TO: Members of the MAG Standard Specifications and Details Committee

SUBJECT: MEETING NOTIFICATION AND TRANSMITTAL OF TENTATIVE AGENDA

MAG Standard Specifications and Details Committee
TENTATIVE AGENDA
March 7, 2012

ASPHALT PAVEMENT
SAFETY EDGE

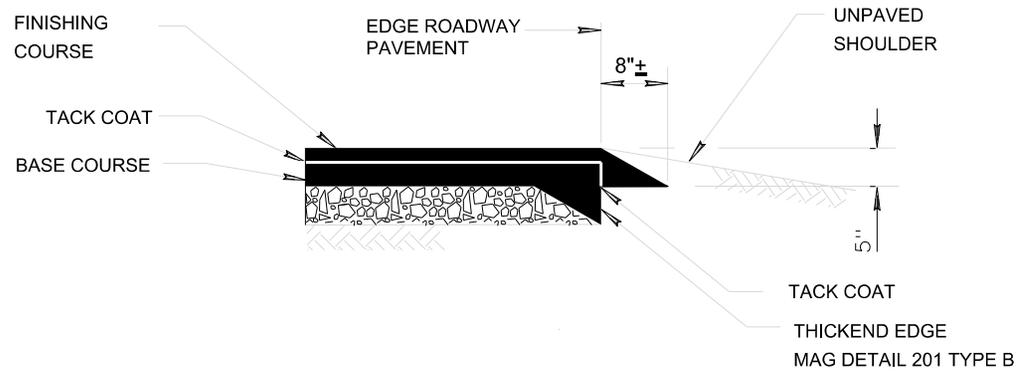
Add an Asphalt Pavement Safety Edge option to Detail 201. Bob Herz handed out a new detail drawing dated 2/1/12 that showed revised safety edge sections for both overlay and new pavement based on the county's experience with a shoe recently received. He said the revisions were based on the edge produced by the shoe with dimensions of 8" wide and 5" deep. He also said they tried constructing the edge without a shoe, and had difficulty getting compaction. Maricopa County decided to keep the thickened edge detail and add the safety edge overlay. They will be testing this method on a demonstration project in March. Mr. Benedict asked Mr. Herz about existing construction projects. He replied that they will likely be sending out revised details similar to the one provided to the committee, but that the details were still a work in progress. Tom Wilhite asked if there would be changes to the written specifications. Mr. Herz said that there likely would, but that he was going to wait until after their demonstration project and make changes based on their experience with it.

321.8.8 Safety Edge: Prior to commencing paving operations that require construction of a safety edge, the Contractor shall submit for the Engineer's approval construction procedures to be used for placement and compaction of the safety edge.

The finished safety edge slope shall be planar and form a $30^\circ \pm 5^\circ$ angle with the horizontal plane. Due to the required final edge slope of the safety edge, compaction as required by sections 321.8.4 and 321.10 may not be attainable. When the approved procedures for placement and compaction of the safety edge are followed, the safety edge compaction shall be considered acceptable.

DETAIL NO.
3008-1

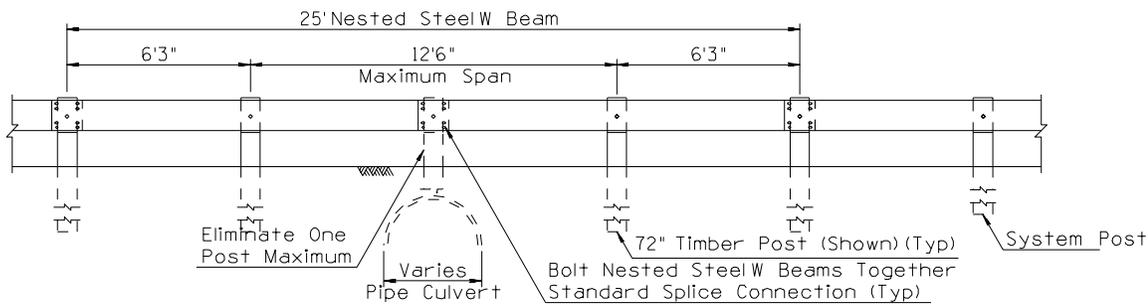
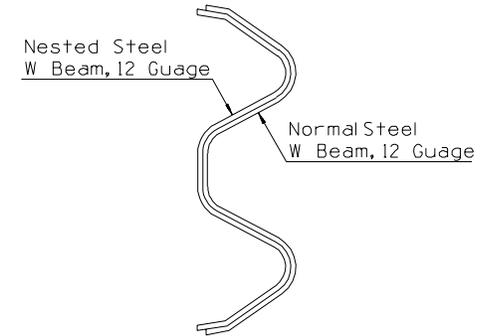
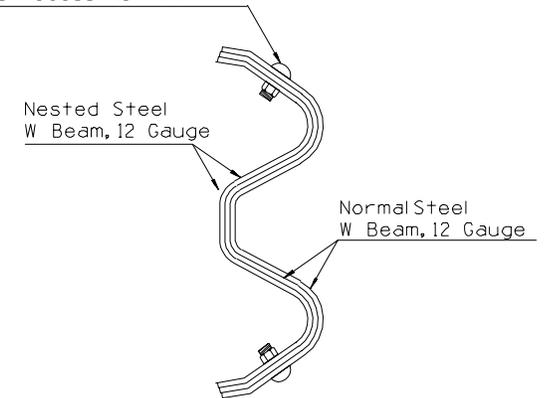
415.3.5 Nested Guardrail: This work shall consist of furnishing and constructing nested guardrail, Type 1, 2, or 3, as shown in Maricopa County Department of Transportation Standard Details 3008-1 through 3008-3, including all materials, in accordance with the requirements of the project plans.

DETAIL NO.
3010-1

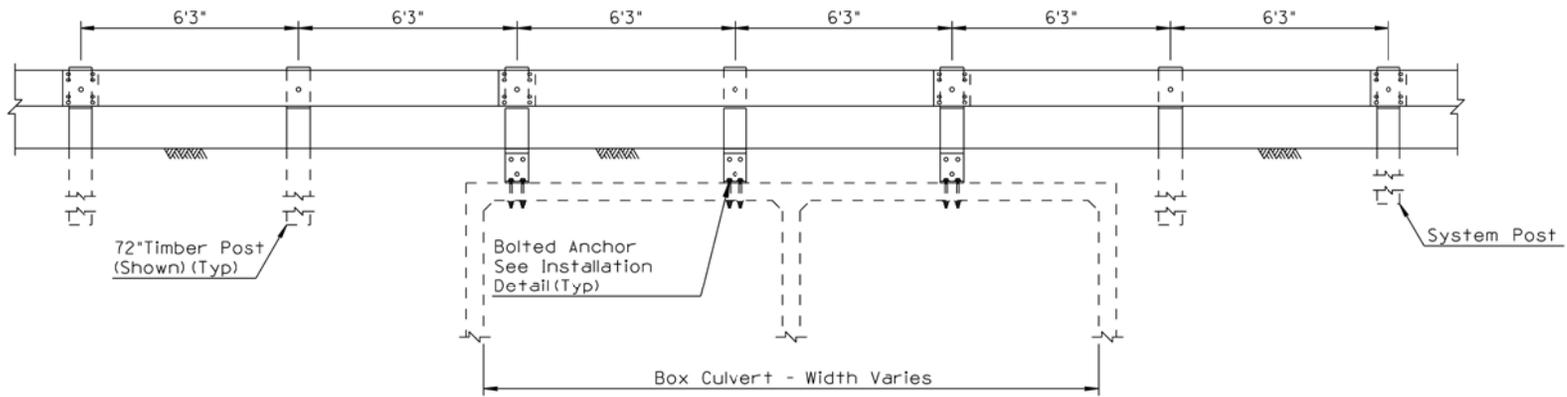
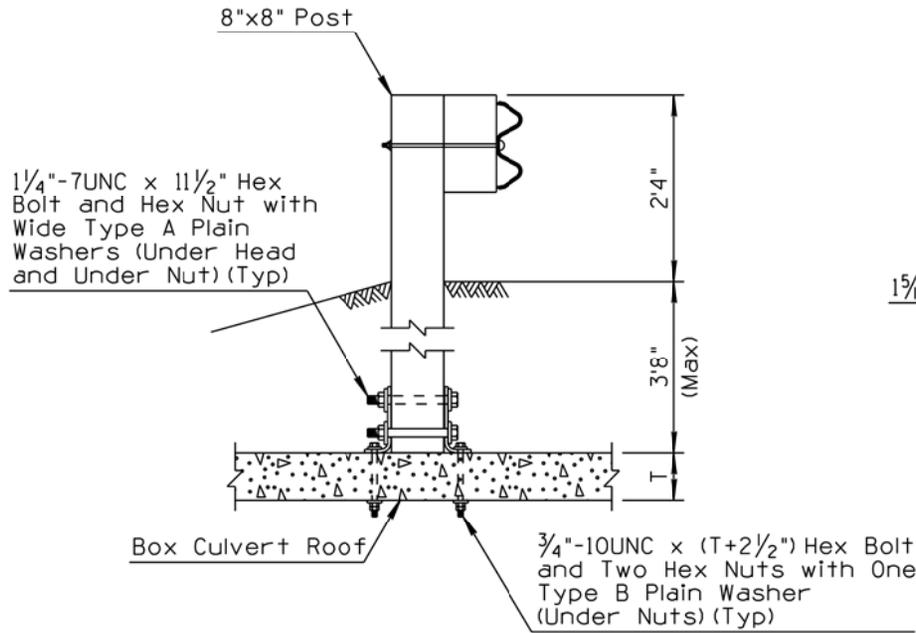
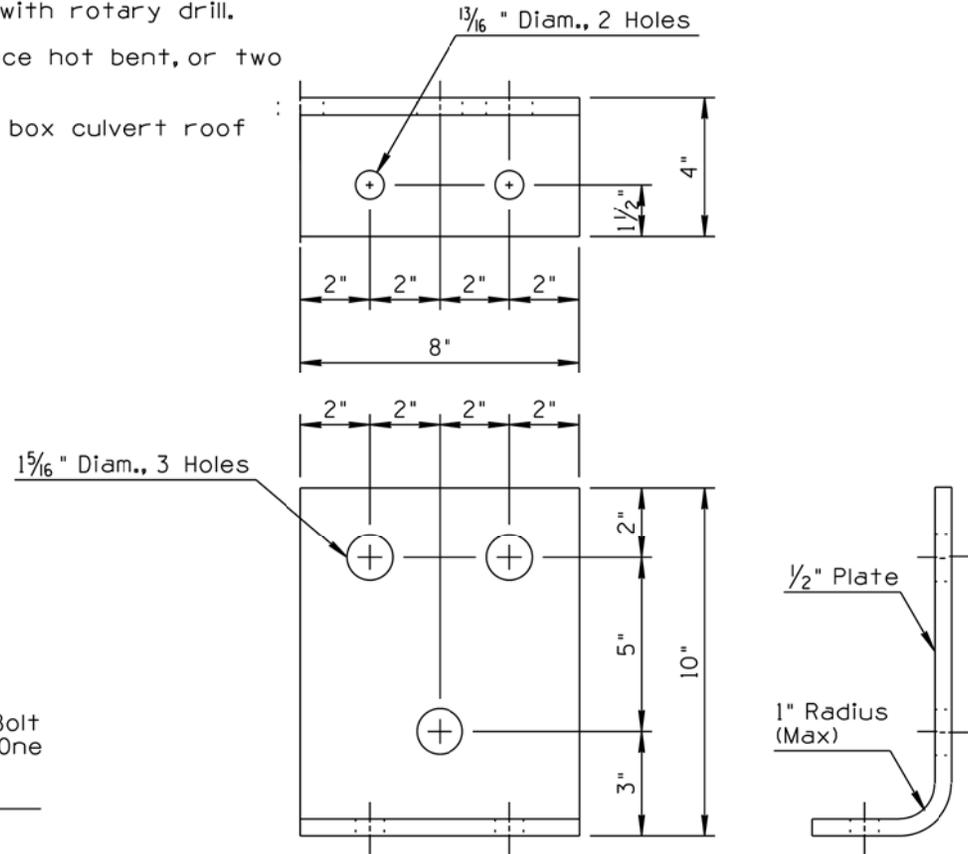
415.3.4 Bolted Guardrail Anchors: Where the elevation of the top surface of a box culvert or other similar installation prevents the placement of a post of the specified length, the posts shall be shortened and anchored in accordance with Maricopa County Department of Transportation Standard Details 3010-1 and 3010-2 at the locations shown on the plans.

DETAIL NO.
250-2

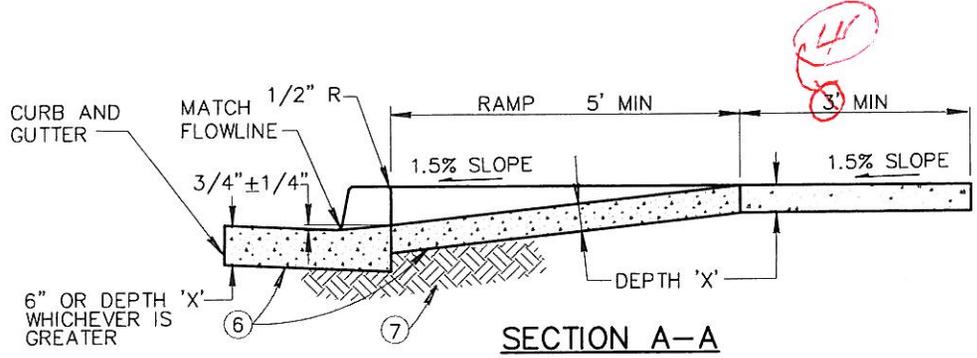
Subject: Proposed revision to Standard Detail 250-2 DRIVEWAY ENTRANCES WITH SIDEWALK ATTACHED TO CURB **Case 12-03**

PURPOSE: Revise the minimum sidewalk width to comply with the modified ADA requirement contained in the Proposed Guidelines for Public Rights-of-Way.

REVISION: Change the minimum width shown at two locations in Detail 250-2 from 3' to 4'.
